Figure 3.22: Baseline Surface Water flows at Stream locations north-east of the site

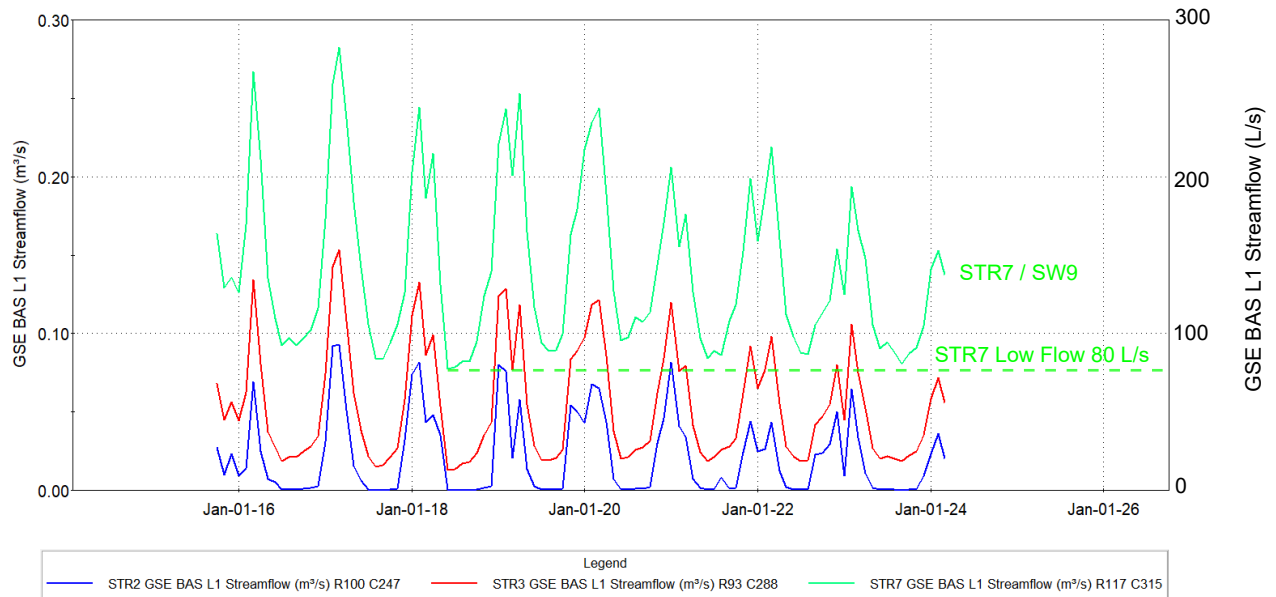
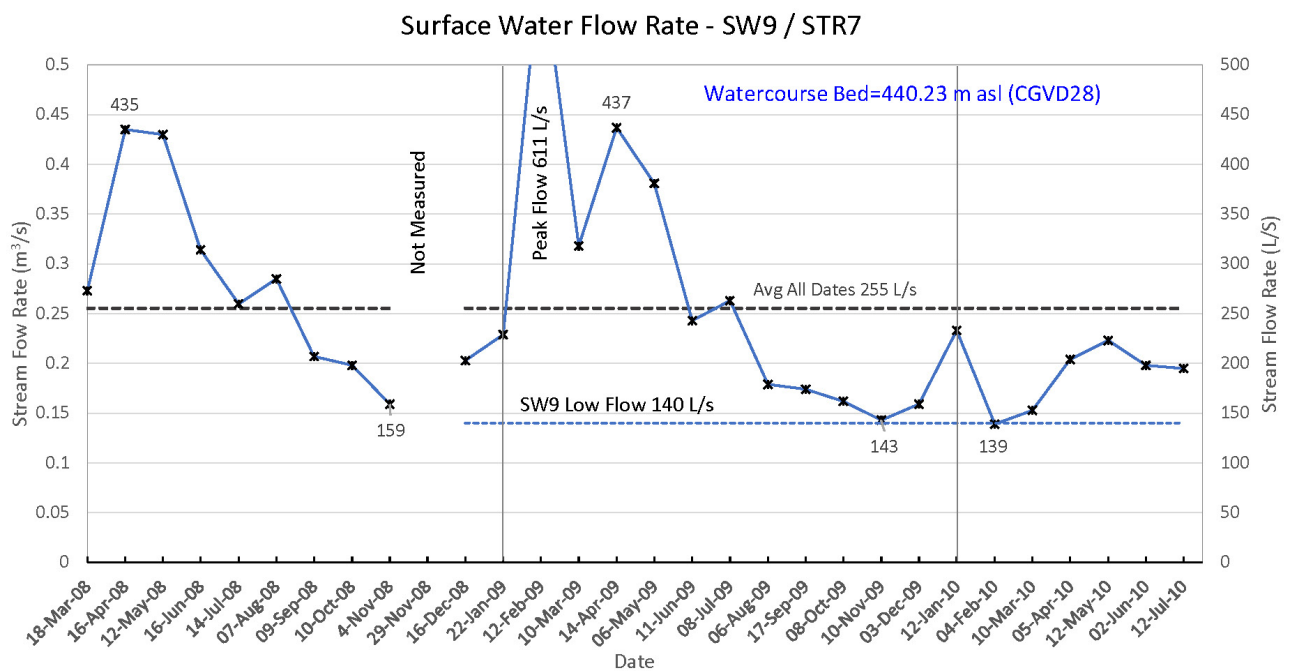
Strada Model Virtual Baseline Flow $80/140 \times 100 = 57\%$ of Mega Quarry Real Flow.
